## DEPARTMENT OF PLANNING AND ZONING

Re: DSUP2015-00018 King St Exchange (1625 Prince St) Completeness Comments

**Emergency Vehicle Easements**

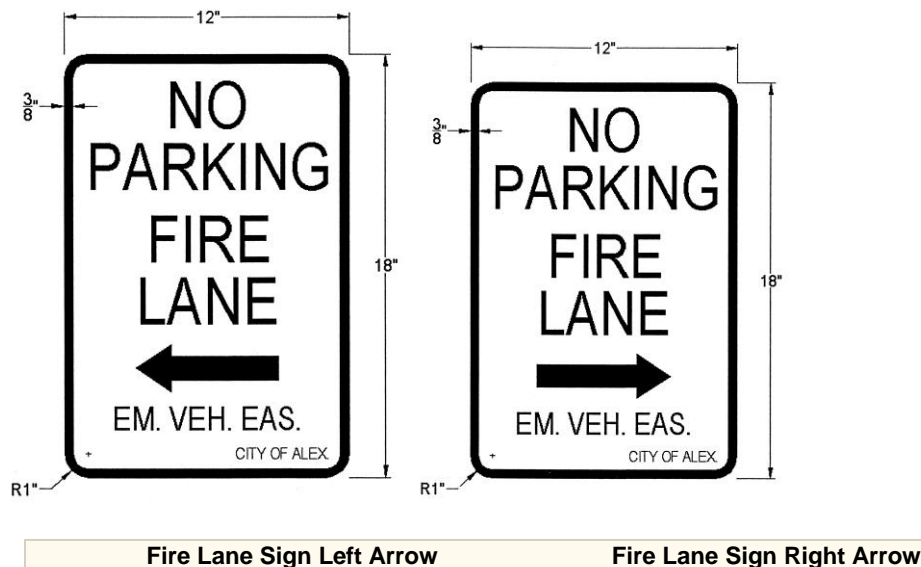
- C-4 The final site plans shall show placement of emergency vehicle easement signs. See sign detail and placement requirements below.

**Emergency Vehicle Easements.** Emergency vehicle easements shall be a minimum of 22 feet across the travel lane. The emergency vehicle easement shall provide access to strategic areas of the building and fire protection systems. Curbing and street components shall conform to the

**Sign Specifications.** Emergency vehicle easement signs shall be metal construction, 12-inches wide and 18 inches in height. Provide red letters on reflective white background with a  $\frac{3}{8}$ -inch red trim strip around the entire outer edge of the sign. The lettering shall say "NO PARKING," "EMERGENCY VEHICLE EASEMENT," "EM. VEH. EAS.," and "City of Alex.," Lettering size shall be as follows: "NO PARKING" - 2 inches, "EMERGENCY VEHICLE EASEMENT" - 2½ inches. EM. VEH. EAS. - 1 inch, CITY OF ALEX. - ½ inch. Directional Arrows - 1 inch by 6 inches solid shaft with solid head - 1½ inches wide and 2 inches deep (For examples, see Figures D102.1, D102.2, and D102.3). Signs shall be mounted with the bottom of the sign 7 feet above the roadway, and shall be properly attached to a signpost or other approved structure such as designated by the fire official. Posts for signs, when required, shall be metal and securely mounted. Signs shall be parallel to the direction of vehicle travel and posted so the directional arrows clearly show the boundaries and limits of the Emergency Vehicle Easement. In areas where emergency vehicle easements involve two-way traffic, double mounted signs shall be provided. The maximum distance between signs shall be 100 feet. Other special signs or modifications to emergency vehicle easement signs shall be approved by the fire official.

**Fire Dept. Access Lanes/Mountable Curbs.** Where curbing is a component of the emergency vehicle easement, the curbing construction shall conform to weight and grade requirements for vehicular traffic. In no circumstances shall a raised curb be located in the path of travel in an emergency vehicle easement. Where a mountable curb is provided as part of an emergency vehicle easement, emergency vehicle easement signs shall be posted at the point nearest the edge of the emergency vehicle easement, but in no case within the clear width of the emergency vehicle easement.

**Acknowledged by applicant.**
